CITY of NOVI CITY COUNCIL

Agenda Item 5
October 8, 2018

SUBJECT: Consideration of tentative approval of the request of McBride Dale Clarion for Speedway at 14 Mile and Haggerty, JSP 17-63, with Zoning Map Amendment 18.720, to rezone property in Section 1, located at the southwest corner of Fourteen Mile Road and Haggerty Road from OST (Planned Office Service Technology) and B-3 (General Business) to B-3 (General Business) subject to a Planned Rezoning Overlay (PRO) Agreement, and corresponding PRO Concept Plan. The property totals 2.03 acres and the applicant is proposing to update and rebuild the whole site.

Rezoning Request from OST (Office Service Technology) & B-3 (General Business) to B-3 (General Business) with Planned Rezoning Overlay (PRO) – Second Revised Concept Plan

2224 - CS

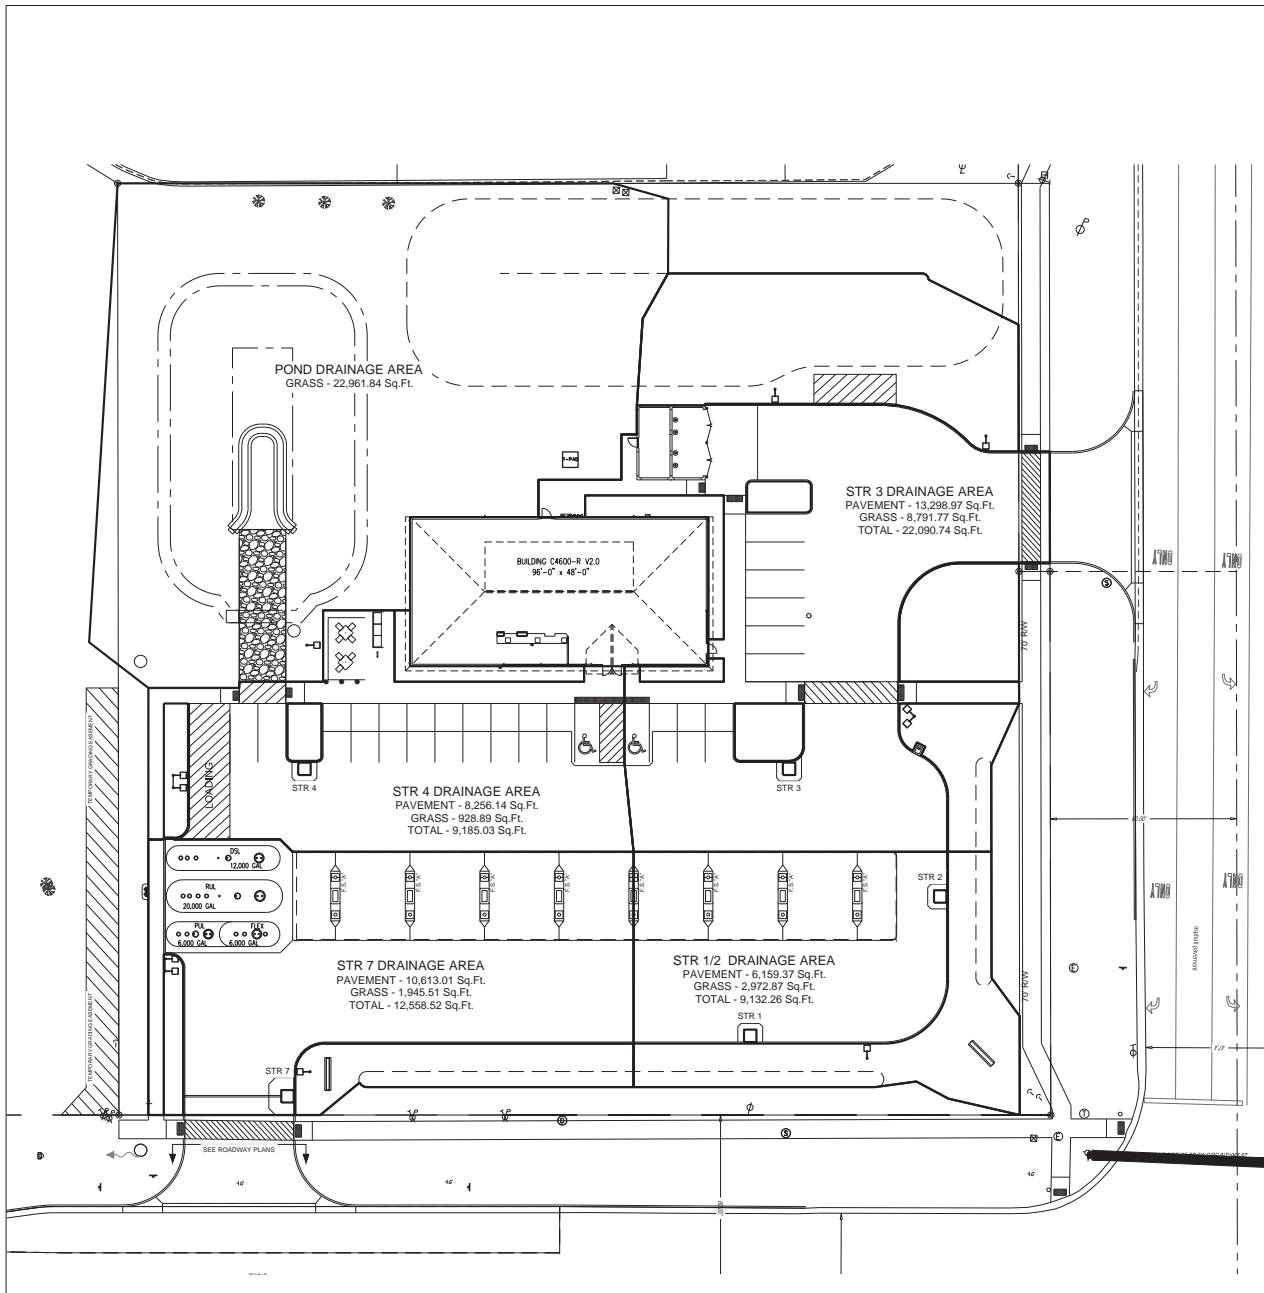
- a. The City requires one parking space per each fuel dispensing stand and one parking space for each 200 square feet of usable building space which results in a total of 39 required spaces. The applicant should revise the required parking section on sheet 2224-CS to reflect 39 spaces required.

- c. The applicant has proposed 19 foot long parking spaces with a seven inch curb. The applicant should reduce the curb height to six inches to be compliant with City standards. Reference Section 5.3.2 of the City's Zoning Ordinance for more clarification. Note E-9 on sheet 2224-CS refers to type F-4 curb which is six inches, however, the detail on sheet 2224-CS1 is type C-4 which is seven inches.

7. The applicant should provide notes and details related to proposed pavement markings.
 1. The applicant should update the Note F-3 on sheet 2224-CS to indicate white striping for standard spaces. Blue may be used for accessible parking spaces. Where a standard parking space is located next to an accessible parking space a white line shall abut a blue line.

33. Label specific ramp locations on the plans where detectable warning surface is to be installed. **Refer to sheet 2224-CS.**

2224 - CU

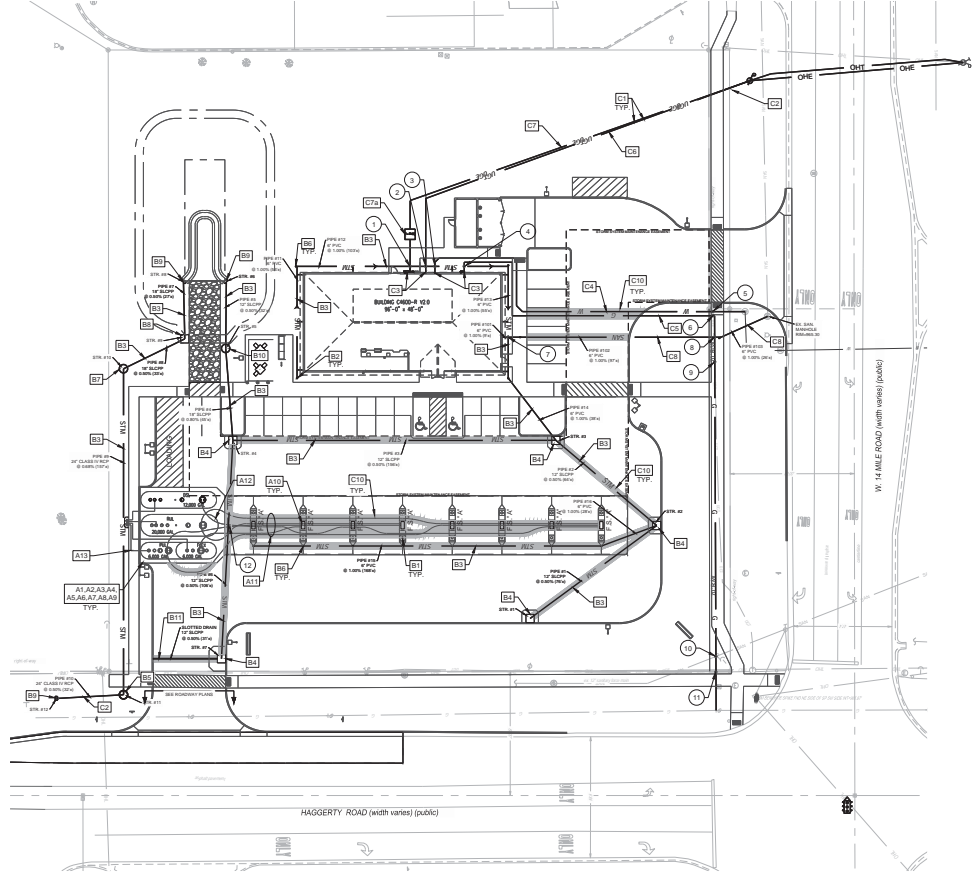
Provide a construction materials table on the Utility Plan listing the quantity and material type for each utility (water, sanitary and storm) being proposed. **Refer to materials table on sheet 2224-CU. Table will be updated to reflect the correct quantities.**

7. Provide a note stating if dewatering is anticipated or encountered during construction a dewatering plan must be submitted to the Engineering Department for review. **Refer to note on sheet 2224-CU.**

9. Indicate invert elevations of sanitary sewer. **Refer to sheet 2224-CU.**

11. Indicate ADS High Performance or RCP class IV or class V pipe for storm sewer. Ensure connections to structures are per pipe manufacturer's recommendation. **Refer to sheet 2224-CU for piping material callouts.**

12. Storm sewer in the R.O.W. must be RCP, class IV or class V. **Refer to sheet 2224-CU for piping material callouts.**
13. Provide profiles for all storm sewer 12-inches or larger. **Refer to sheets 2224-CU-1 through 2224-CU-2.**

14. Provide storm sewer sizing calculations. **Storm sewer calculations will be provided with the next submittal.**
15. Label all inlet storm structures on the profiles. Inlets are only permitted in paved areas and when followed by a catch basin within 50 feet. **Refer to sheet 2224-CU.**

DESIGN TEAM DATE
R. THORNTON 08/14/17
R. BAIRD 08/14/17
M. NIOSHANG 08/14/17
2224 - CU3

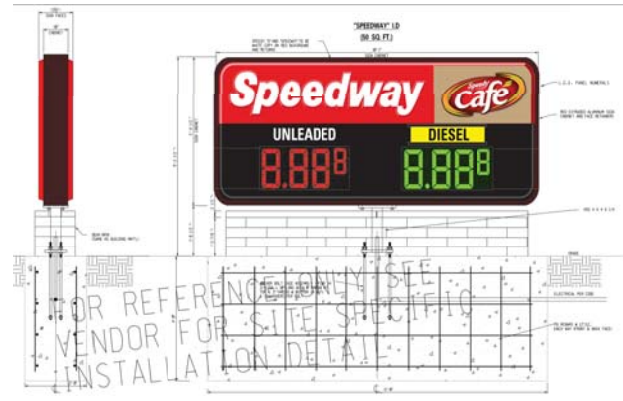
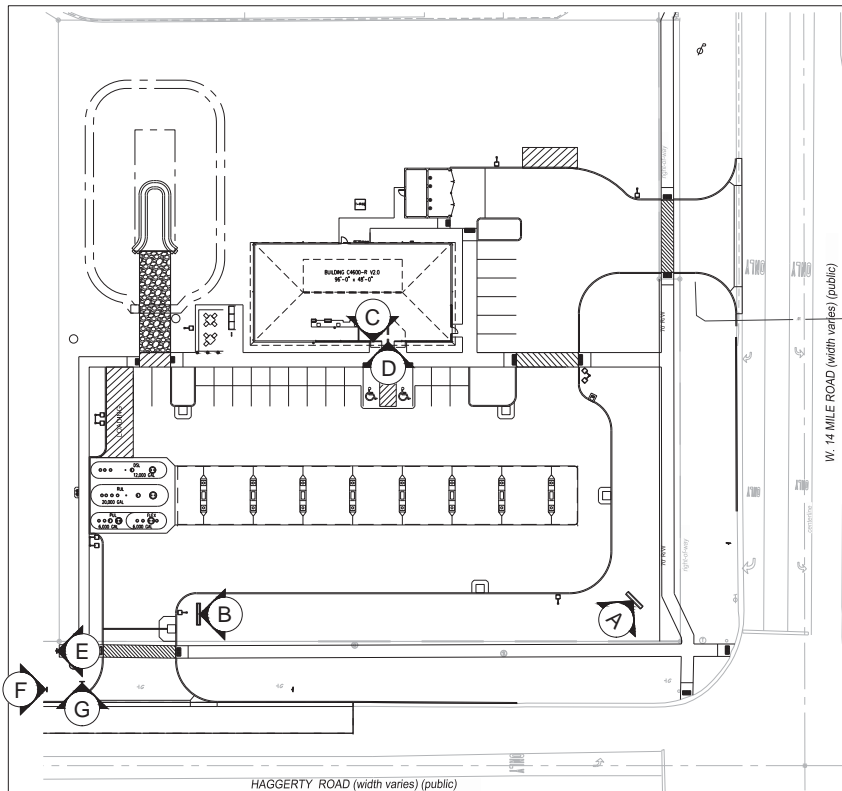
17. Provide a four-foot deep sump and an oil/gas separator in the last storm structure prior to discharge to the storm water basin. **Refer to the Aqua swirl detail on 2224-CU3**

20. Provide a cross-section for the proposed basin outlet. **Refer to outlet control structure detail on sheet 2224-CU3.**
21. Provide manufacturers details and sizing calculations for the pretreatment structure. Provide drainage area and runoff coefficient calculations specific to the area tributary to the treatment structure. The treated flow rate should be based on the 1-year storm event intensity (~1.6 In/Hr), resulting in a flow rate of approximately 2.35 CFS. Higher flows shall be bypassed. **See Aqua Swirl detail on sheet 2224-CU3. Sizing calculations will be provided on this sheet for this structure.**

23. Provide release rate calculations for the three design storm events (first flush, bank full, 100-year). **Refer to sheet 2224-CU3 for pond release rate calculations.**

2224 - SS

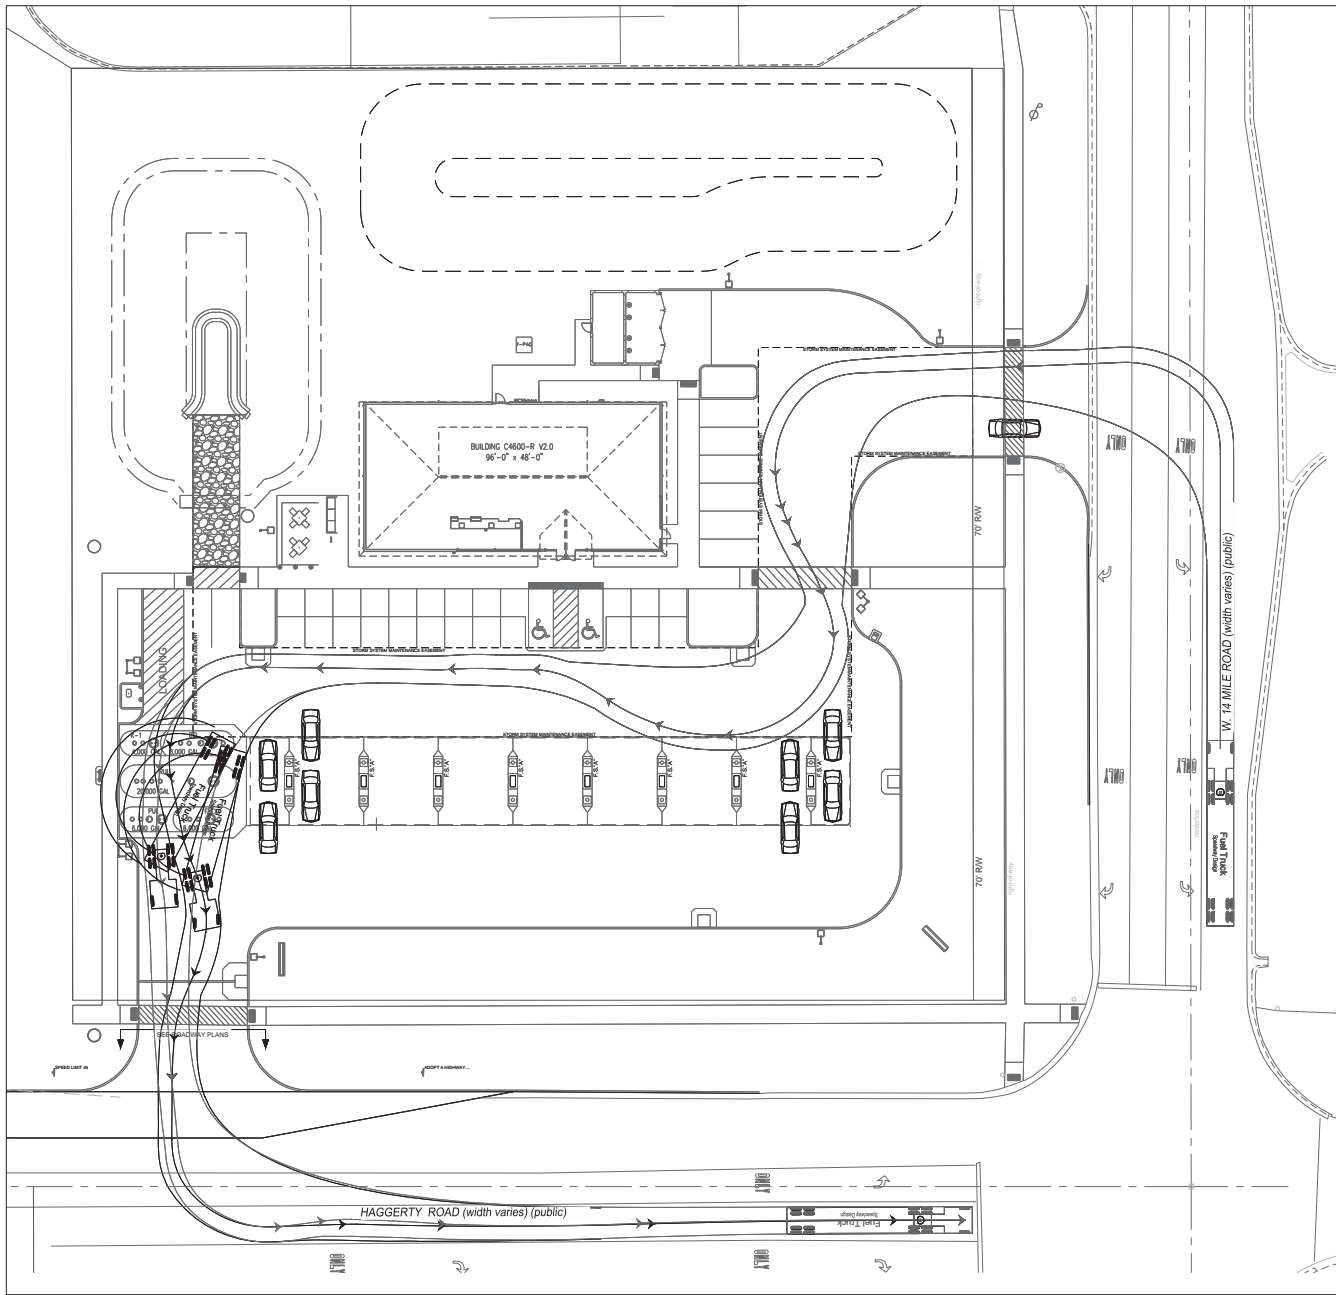
3. The applicant should provide signing quantities and details, including size, MMUTCD designation and post, in future submittals.
 4. The speed limit sign on sheet 2224-SS should be 45 MPH for Haggerty Road and not 50 MPH.
